8 CHIFLEY SQUARE SYDNEY

SYDNEY METRO EIS IMPACT REVIEW

REPORT NO. 16224
VERSION A

Figure 2-1 8 Chifley Square looking from Proposed Northern Access Site

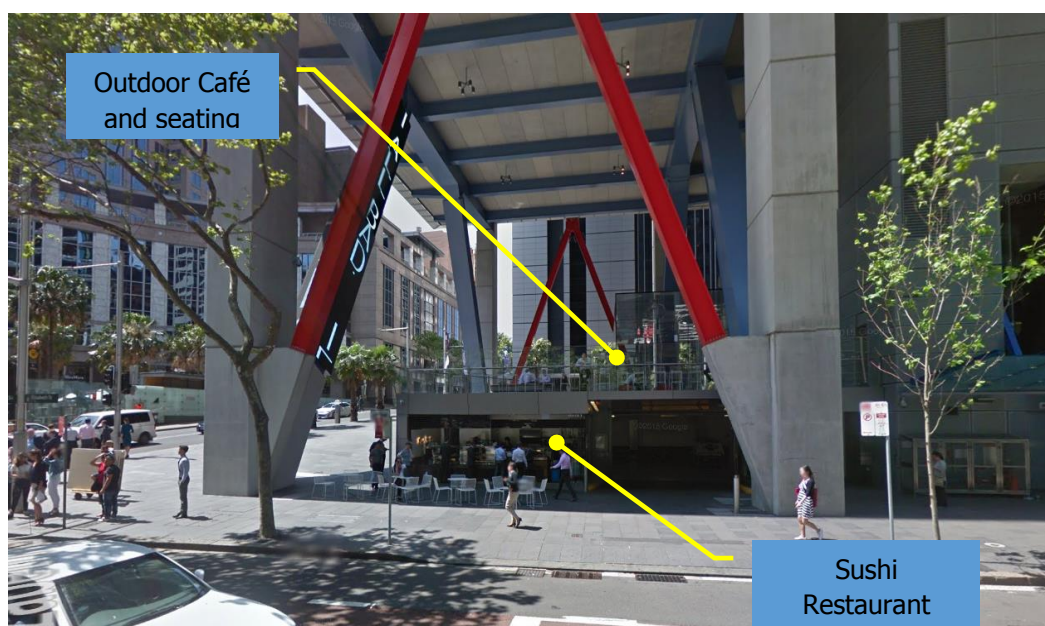
The EIS fails to identify either the café or Sushi Restaurant which are located on the site. As

such a lower noise management level of 60 dBA is applicable at these receivers.

This will result in an exceedance of noise management levels at the café and Sushi Restaurant of between 20 and 30 dBA. In lower office areas of the building this translates to an internal noise level at the Northern and Western Facade of approximately 60 to 70 dBA. This will:

- Limit effective communication in the outdoor café area and Sushi Restaurant to 0.25 metres and require a shouting voice effort.
- Impact on communication on in the Foyer.
- Impact on communication in the lower levels of office areas on the western side of the building where effective communication would require raised voice efforts at distances of 1 metre.
- Impact on the internal acoustic amenity of office workers on lower levels.
